Determination 2023/010

Regarding the authority's decision to refuse to grant an application for a building consent for building work to enclose an existing carport

264 McShane Road, Wainui Bay, Tasman District

Figure 1: Floor plan (not to scale)

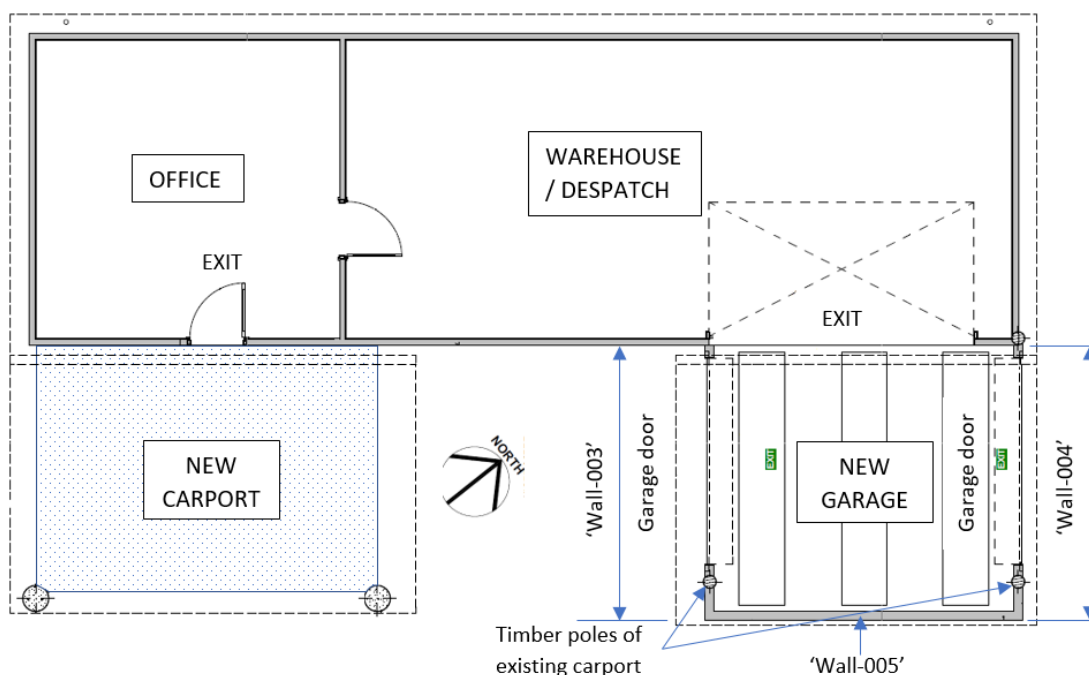
- (1) Drawings 201, 500 and 501 state the 140 x 45mm wall framing studs are to be fixed generally at 600mm centres. However, detail D-03 on drawing 202 states the same studs are to be at 400mm centres, and detail D-04 on drawing 202 and drawings 300 and 701 states the studs are to be at 450mm centres.

- (2) Regardless, the framing design appears to be non-compliant with NZS 3604:2011, Table 8.4 – Studs in non-loadbearing walls for all wind zones.⁴⁰ For example, ‘wall-005’ is dimensioned on drawing 501 as 4988mm high with 140mm x 45mm studs at 600mm centres.⁴¹ For a high wind zone⁴², NZS 3604:2011 provides required dimensions and spacings for non-loadbearing studs up to a maximum of 4.8m long.

- (3) There appears to be no fixings specified or shown in detail D-04 on drawing 202 for securing the top plate of ‘wall – 005’ to the existing carport structure or roof.⁴³ In addition, the rafters shown penetrating ‘wall-005’ in detail D-04 are not shown in the wall framing elevation on drawing 501.⁴⁴ Further, it is also not clear how the top plates for ‘wall-003’ and ‘wall-004’ are to be fixed.⁴⁵

- (5) It is not clear how or if external wall types ‘wall-003’ and ‘wall-004’ are intended to be fixed to the existing 200mm diameter timber poles.

- (1) Detail D-03 on drawing 202 states the concrete footing to the new external wall is to be 200mm wide x 200mm deep. However, drawing 701 states the "slab foundation footing" is 300mm wide x 300mm deep.

- (2) In his response to the authority the designer said that 200mm into good ground complies with NZS 3604:2011 for non-loadbearing walls, but, while not dimensioned, detail D-03 on drawing 202 shows the foundation approximately 100mm into the ground. The detail is not in accordance with NZS 3604:2011 paragraph 3.4.2, which requires "the minimum depth of footings below the cleared ground level shall be 200mm, subject to satisfying expansive soil requirements".

- (3) Detail D-03 on drawing 202 does not comply with NZS 3604:2011, paragraph 7.5.2.1 and figure 7.11 (A) which requires the finished concrete floor level of the slab to be a minimum height of 150mm above adjacent permanent paving, or otherwise 225mm. Detail D-03 indicates the finished concrete level would be approximately 100mm above the finished ground level.⁽⁴⁷⁾⁽⁴⁸⁾

5.13.3. There is no bracing design provided. I note some bracing information is provided on drawing 202. Three bracing elements, which are each 1m long, are shown for 'wall-005', and one bracing element each (700mm long) for 'wall-003' and 'wall-004'. The bracing uses a proprietary plywood system, and the plan does indicate the bracing units achieved for both wind and earthquake loading. However, I am of the view the proposed bracing design is incomplete and contains some errors:

- (1) It is not clear how compliance with Acceptable Solution C/AS2, paragraph 3.15.1 a) is to be achieved; this is in respect of the proposed escape routes through the two new roller shutter garage doors. The issue relates specifically to the requirement that the roller shutter doors are to remain open at all times the space is occupied. This is notwithstanding the proposed escape routes indicated on plans 201 and 202 also pass through an existing roller shutter or tilting door (refer to paragraph 2.4).

- (2) The method used to assess the escape path lengths based on the routes detailed on drawings 201 and 202 does not appear to comply with Acceptable Solution C/AS2, paragraph 3.4.2 c) ie allowance shall be made for the travel distance around obstructions located in the open path. If the location of such obstructions is not known, then the allowable travel distance shall be measured orthogonally. In this case, none of the drawings show the location of any obstructions in the office, warehouse / despatch area, or the new garage.

5.15.3. Drawings 201 and 202 show three large rectangle shapes drawn in the new garage. These are not annotated and therefore it is not clear what they are.⁵⁵
